CALL NO. 200
CONTRACT ID NO. 111043
ADDENDUM # 2

Subject: Caldwell-Lyon-Hopkins Counties, 121GR11D043-NH AND DPR
Letting October 21, 2011

(1) Revised - Plan Sheet - T11

PENNYRILE PARKWAY @ KY 91

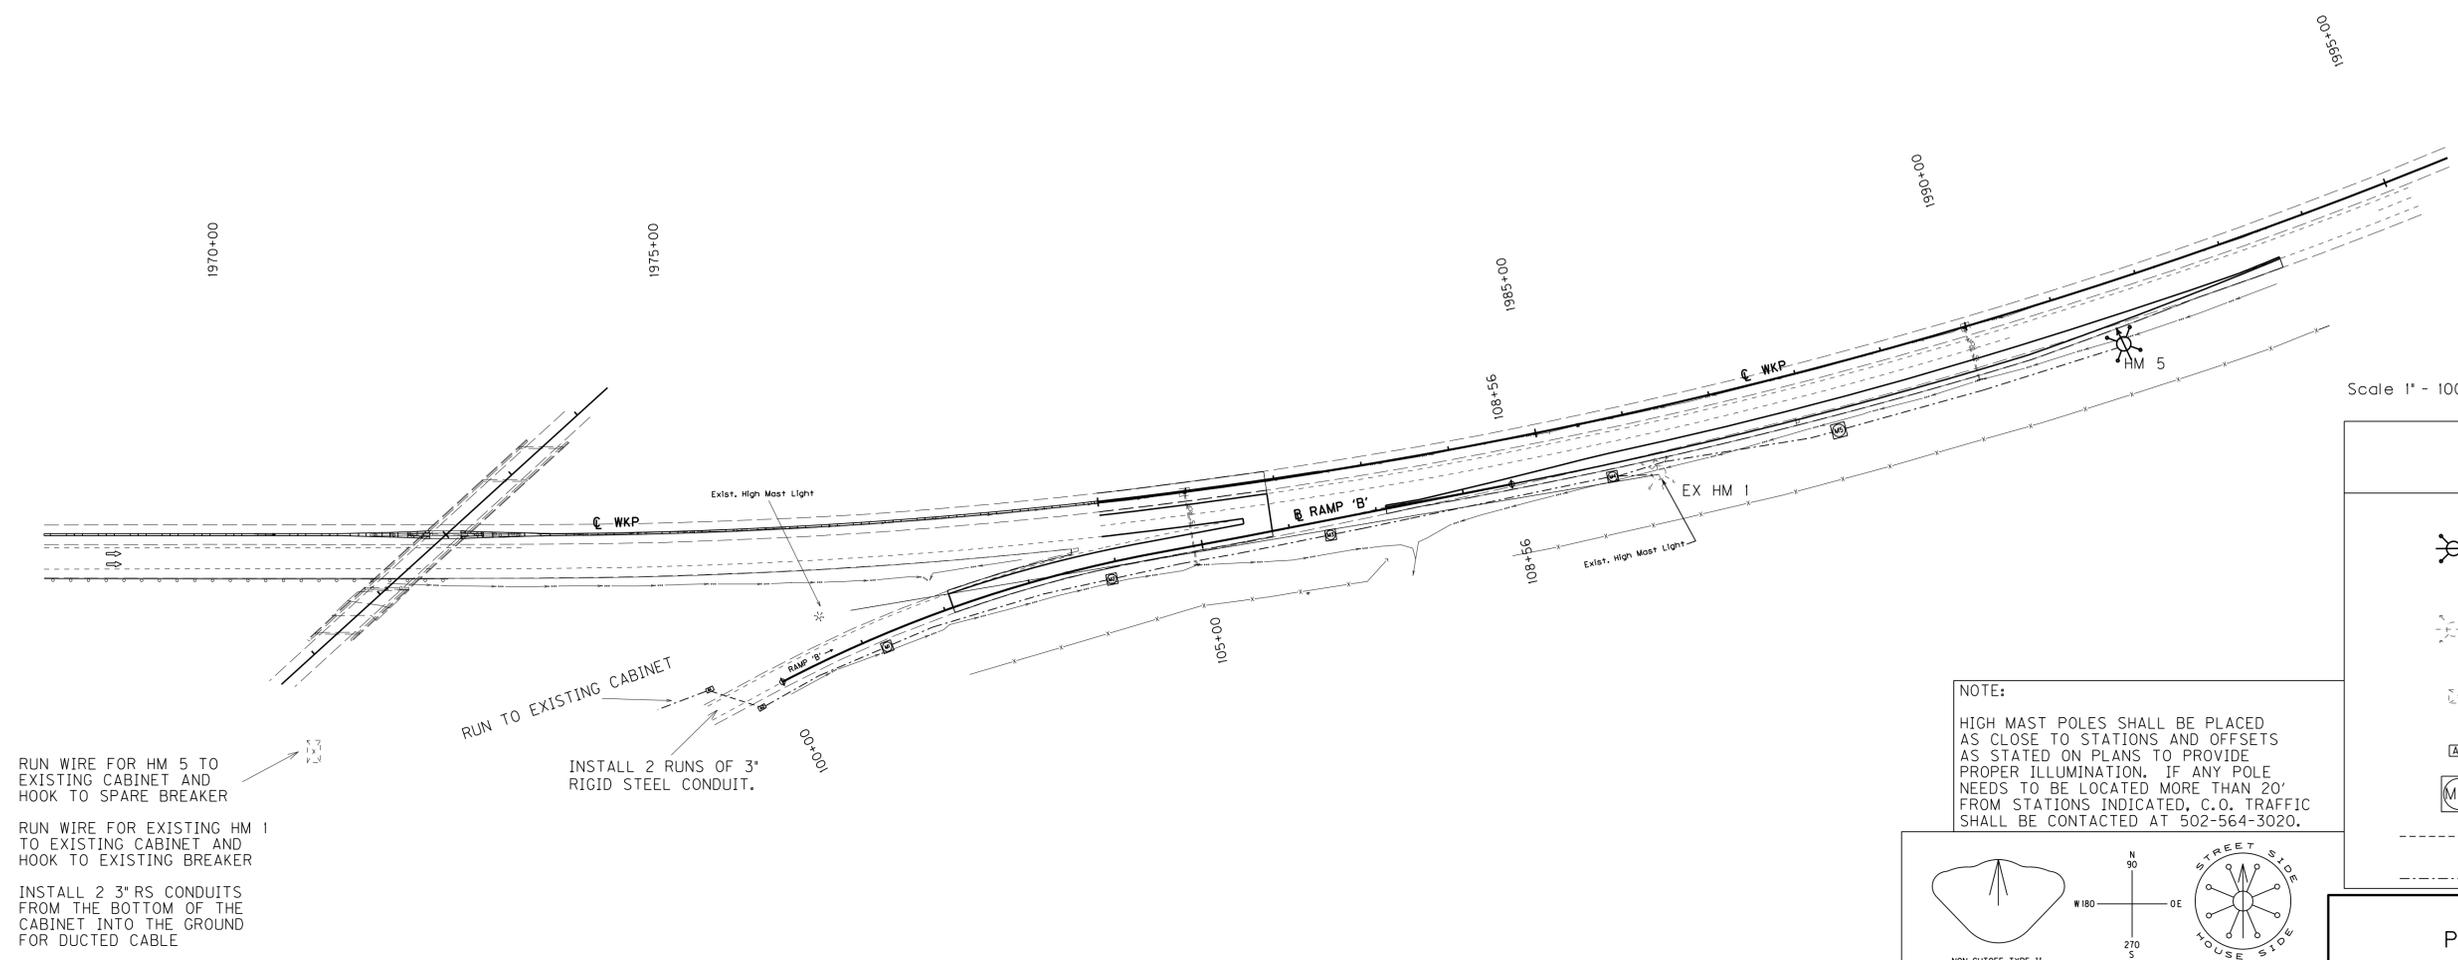
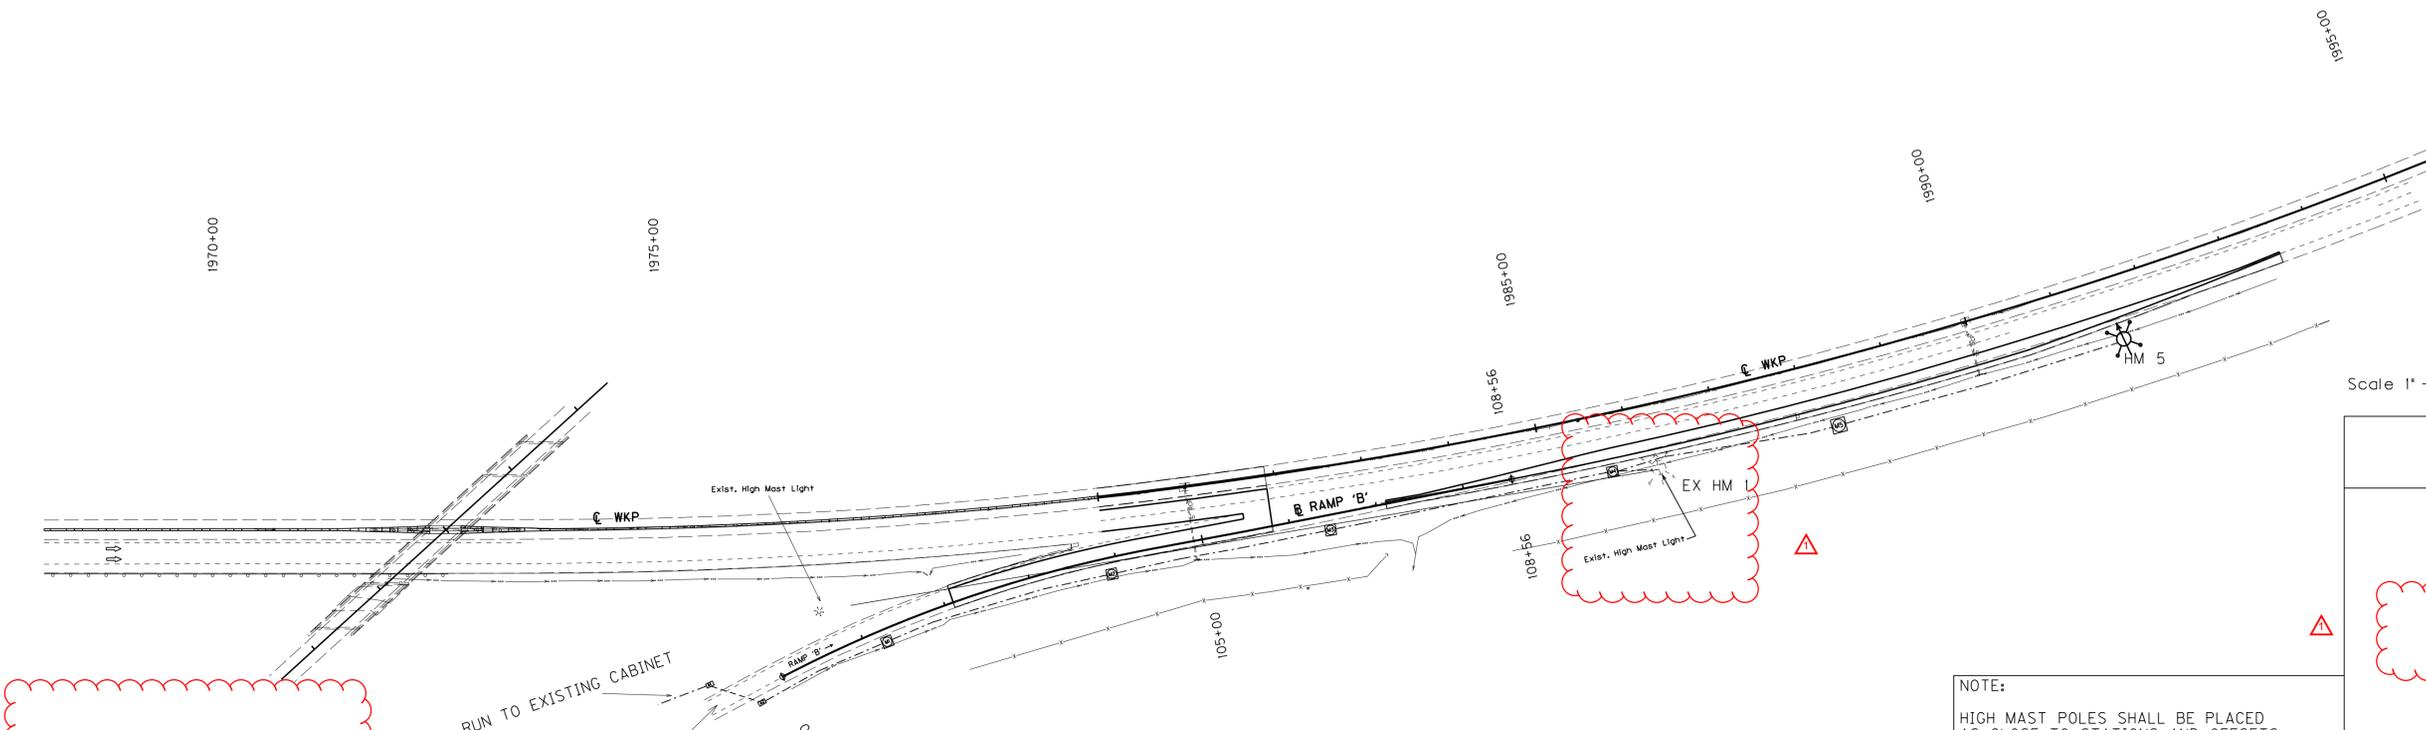
△ REVISED 10-18-11

RUN WIRE FOR HM 5 TO EXISTING CABINET AND HOOK TO SPARE BREAKER

RUN WIRE FOR EXISTING HM 1 TO EXISTING CABINET AND HOOK TO EXISTING BREAKER

INSTALL 2 3" RS CONDUITS FROM THE BOTTOM OF THE CABINET INTO THE GROUND FOR DUCTED CABLE

INSTALL 2 RUNS OF 3" RIGID STEEL CONDUIT.
